Brisbane Central Business District Bicycle User Group

Please find below the feedback of the Brisbane Central Business District Bicycle User Group (CBD BUG) regarding the BCC project concept plan for the North Brisbane Bikeway: (NBB) Bridge St to Kedron Brook (also known as the "Western Branch" / "Wellington Diversion").

Figure 1: Proposed ramp to be built between Lamington Ave and existing underpass

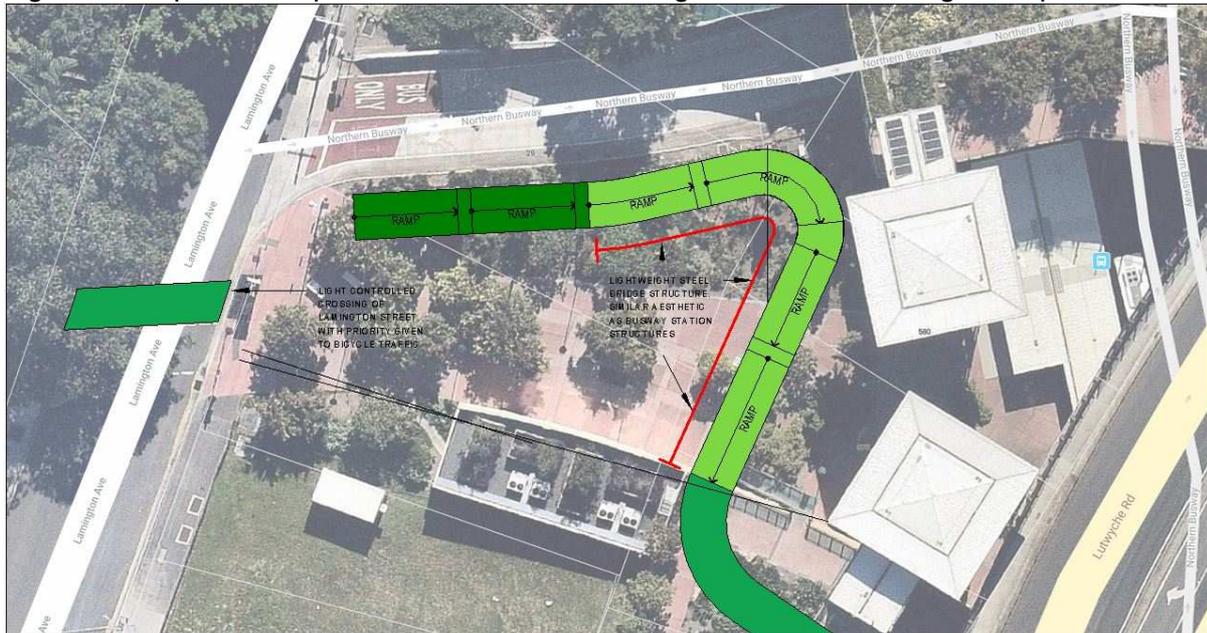
- The CBD BUG is of the view that a ramp should be built between Lamington Ave and the busway underpass (refer Figure 1) in preference to a widened footpath, for the following reasons.
 - This ramp would provide a significantly better and safer connection than a widened footpath.
 - The proposed development on the corner of Lamington Ave and Bradshaw St will effectively minimise the benefits of the widened footpath (to bicycle traffic).
 - If the Wellington Diversion ends up being well used, the capacity of the footpath next to the new building by the busway station will quickly be exceeded.
 - A ramp would be more appealing to riders and therefore a more effective use of money.
 - This footpath widening involves removal of a number of street trees, which typically generates a degree of community opposition

- There is adequate space for a ramp.
- We will be contacting the Transport Minister Mark Bailey, to convey our strong preference for this ramp.
- With a ramp the lights controlled crossing of Lamington Ave should prioritize pedestrian and cyclist movements.
- The BCC proposed crossing of Lamington Ave adjacent to Bradshaw St will be unattractive for many riders and uncomfortable due to traffic conditions, even after the BCC-proposed changes.
- The Lamington crossing is one of the most dangerous parts of the route for existing users. Utilizing the existing crossing in conjunction with the proposed ramp would be much safer.

Figure 4: Intersection of Kedron Park Rd and Chalk St with preferred segregated bicycle lanes

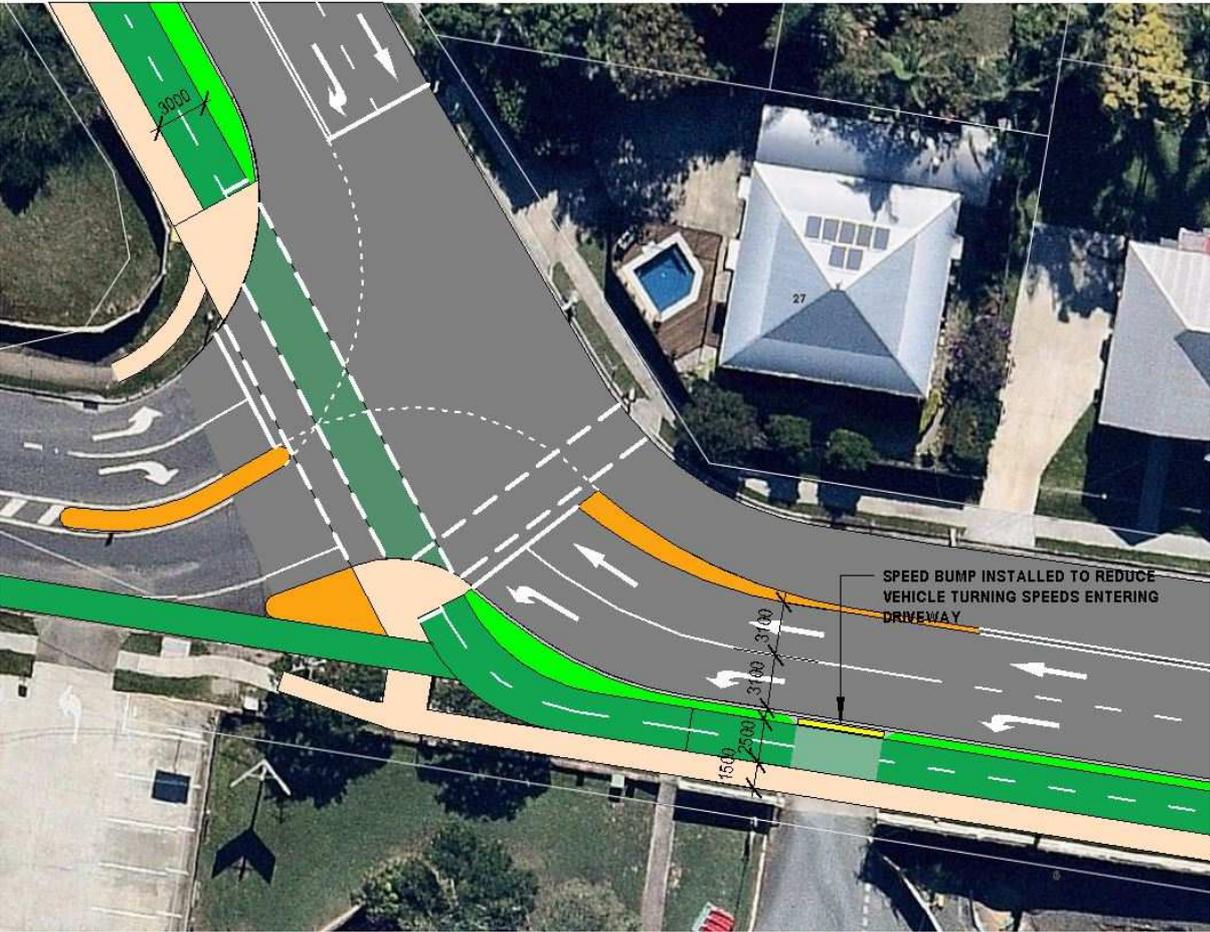
- The CBD BUG believe the proposed intersection needs amendment (refer Figure 4)
- The BCC proposed design with the crossing of Chalk St set back from the intersection creates difficult manoeuvres for a person on a bicycle.

- The CBD BUG views the currently BCC proposed shared path along this section as a highly unsatisfactory solution.
- A shared path would not provide consistent messaging for bicycle movements
- Instead, the CBD BUG has the following proposal (refer Figure 4)
 - 1.5m pedestrian path (as per the Aust Roads minimum)
 - 2.5m cycle path (as per the Aust Roads minimum)
 - 0.5m verge/barrier
- This proposal is only slightly wider than the current BCC proposal of 3.0m concrete path and 1.0m of verge/barrier (total 4.0m)
- The CBD BUG proposal is very similar to what currently occurs along Brisbane St, Toowong (refer Figure 5)
- Design considerations and restrictions for vehicle access must be placed on the development occurring at the former church site.
